4. Box Canyon Subdivision Seavey Addition No. 5

KPB File 2026-039

**ITEM #4 - PRELIMINARY PLAT
BOX CANYON SUBDIVISION SEAVEY ADDITION NO 5**

STAFF REPORT

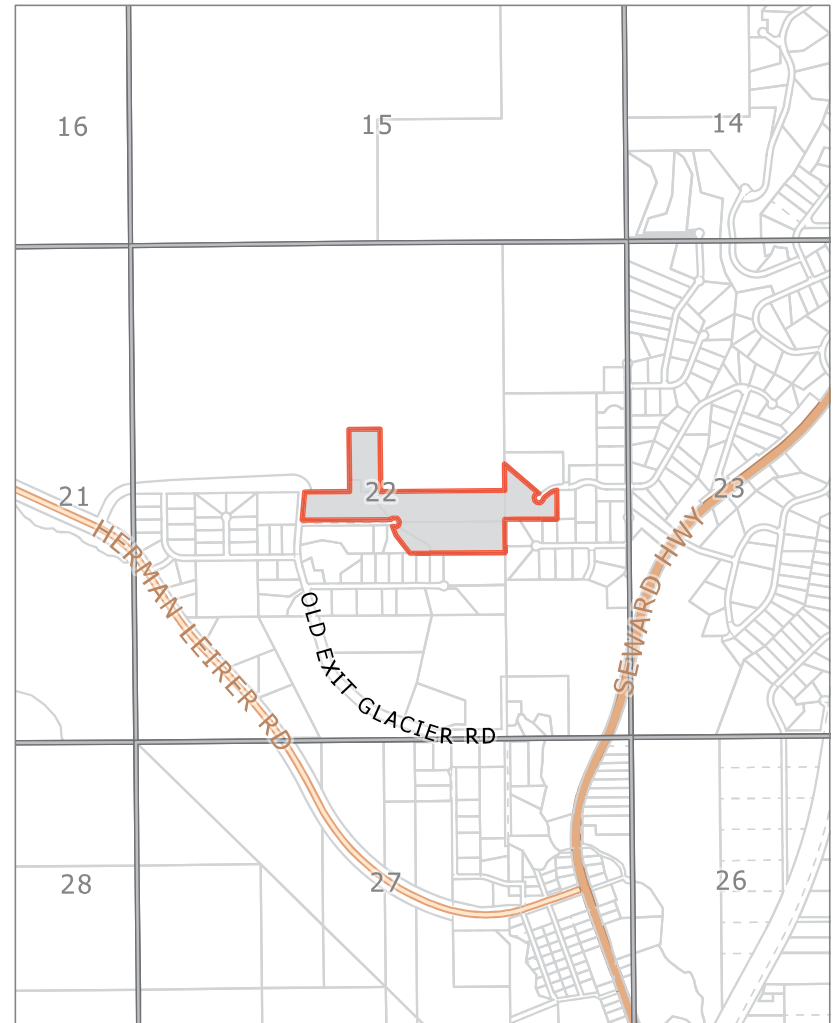
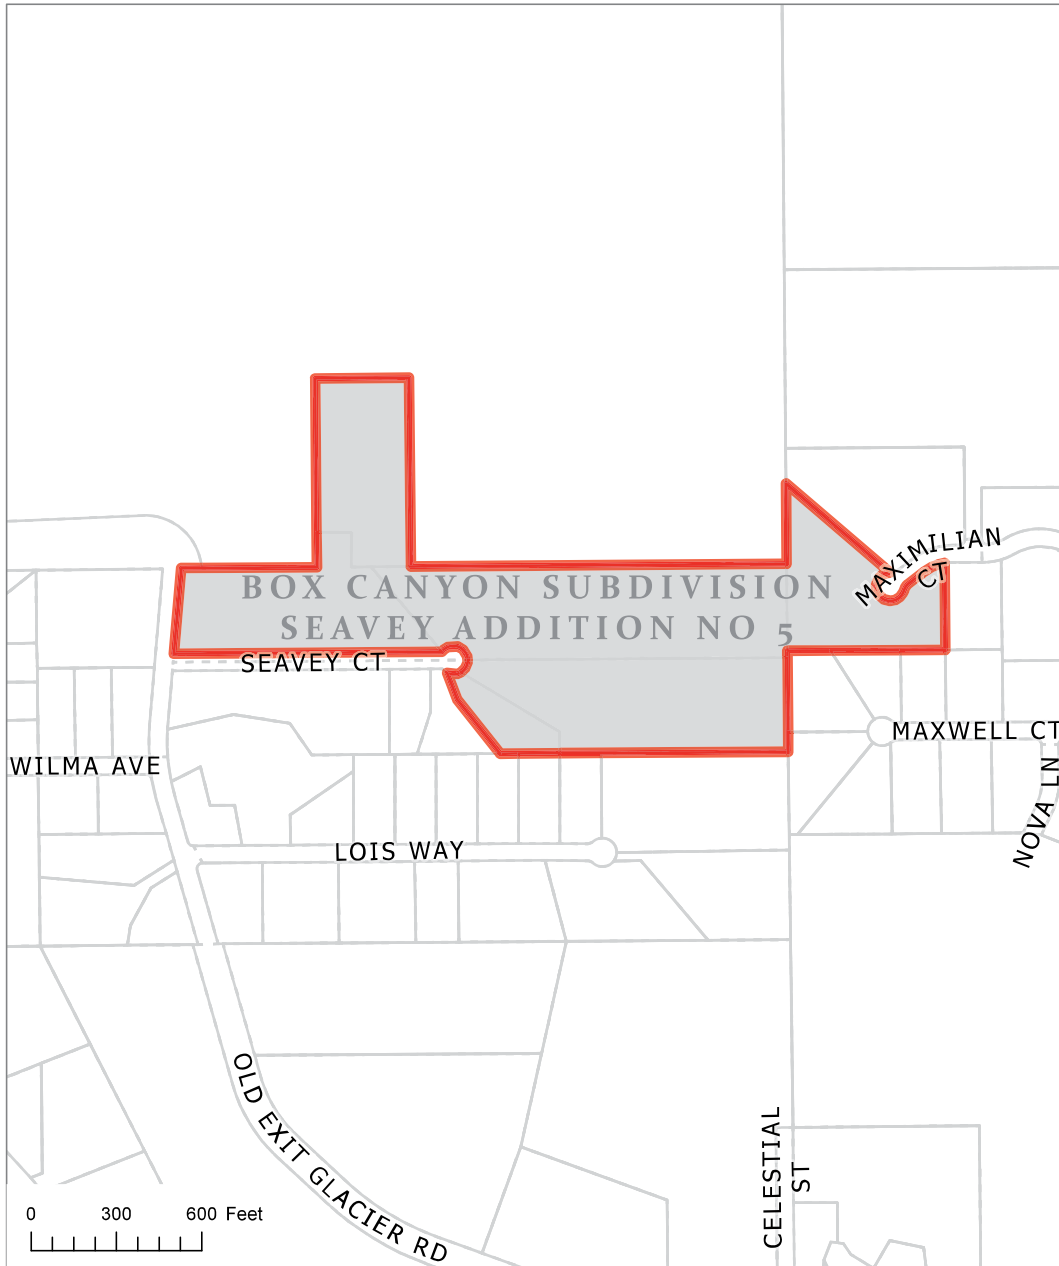
Add Old Exit Glacier Rd to the vicinity map

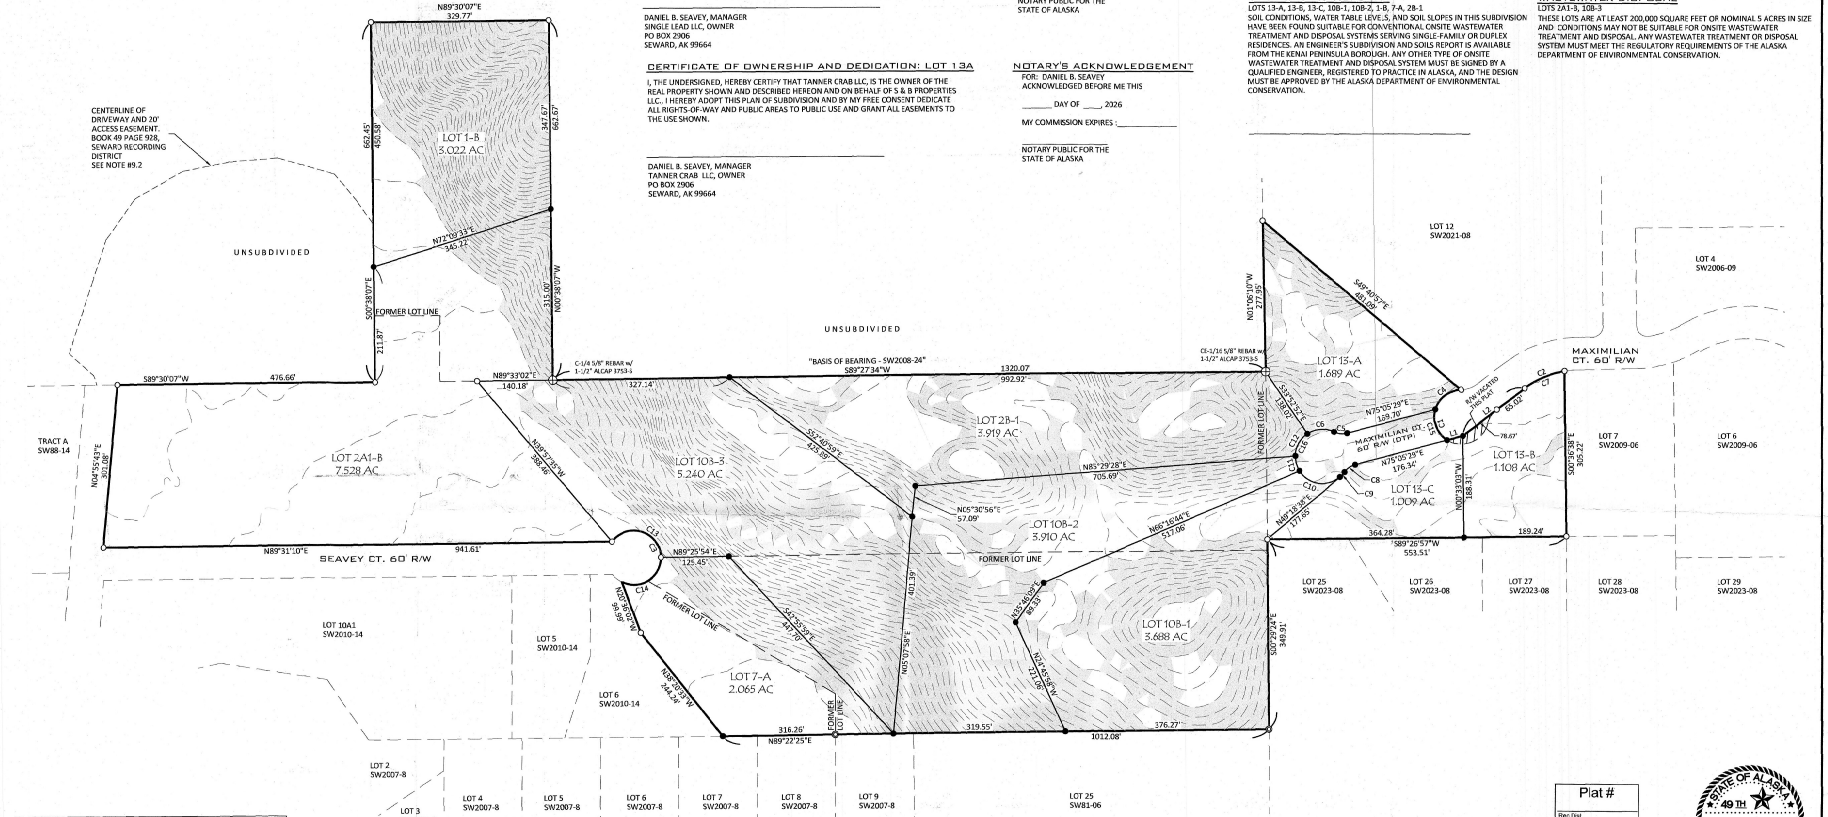
| KPB Roads Dept. comments | Out of Jurisdiction: No Roads Director: Uhlin, Dil Comments: There is a solid line remaining on the previous Maximilian cul-de-sac that needs to be removed. Lot 1-B will be landlocked with this proposed plat. |

Different width of utility easements along the front line by the right-of-way were granted by the different plats. **Staff recommends** the surveyor review the plats and carry forward the larger of the easement for the specific lots and label them and specify in the plat not which lots have which width of utility easement.

There is a Right-of-way Easement listed in Bk 49 Pg 129 of the CTP of Lot 3 Box Canyon Subdivision, which is now part of Box Canyon Subdivision Seavey Addition No 2 SW2009-23 and No 3 SW2010-14. **Staff recommends** the surveyor verify if this easement affects the subject property and if so, show on the drawing and add a plat note.

In the Easement list in Bk 49 Pg 928 of the CTP, there is mention of 10' utility easement. This easement appears to be for a utility line to Lot 1-B crossing the unsubdivided property to the west. **Staff recommends** the surveyor locate this utility as noted and add the location to the drawing and to plat note 9.2.

The plat is finalizing the associated 10' utility easements with the vacation of the portion of Maximilian Ct as noted. The utility easement is not shown on the drawing. **Staff recommends** the surveyor add the utility easement being vacated to the drawing and add notation with the meeting date.

- Noted at Deed of Personal Representative 2025-000954-0 Mitchell Blake Seavey is appointed as Personal Representative for Daniel B Seavey on Lot 1, Box Canyon Subdivision Seavey Addition No 4. If Mitchell is to sign on this plat, please add his name where appropriate. Check the Certificate of Ownerships and Dedications and Notary Acknowledgements for same issues.
- Typical detail needs to be adjusted to accommodate the 15' utility easement noted in SW2015-6.

Modify the KPB File No to 2026-039

Plat name should include Clan Maxwell within it, to include parent plat.

In the legal description, add Lot 7 to Box Canyon Subdivision Seavey Addition No 3 (KN2010-14)

- Tanner Crab LLC, change Lot 13C to Lot 13
- Daniel B Seavey, remove Lot 1 from name
- Single Lead LLC, add Lot 1 to name.

Address for Single Lead LLC as listed at the Assessor Page has two different listed. PO Box 735 and PO Box 2906. Please verify which is correct from the owner and apply to the title block.

Label with name and ROW Old Exit Glacier Rd to the west.

Show a line for between the ROW and Tract E SW2021-8 Along Maximilian Ct

Add Maximilian Dr to the east of Maximilian Ct

- Box Canyon Subd Seavey Ad No 4 grants at note #11 a 15' utility easement along the front right-of-way. This should be carried forward to Lot 2A1-B

To the west, label Lot 6 SW85-4

To the southeast, label Lot 24 SW2023-8

To the northeast, label Tract SW2021-8
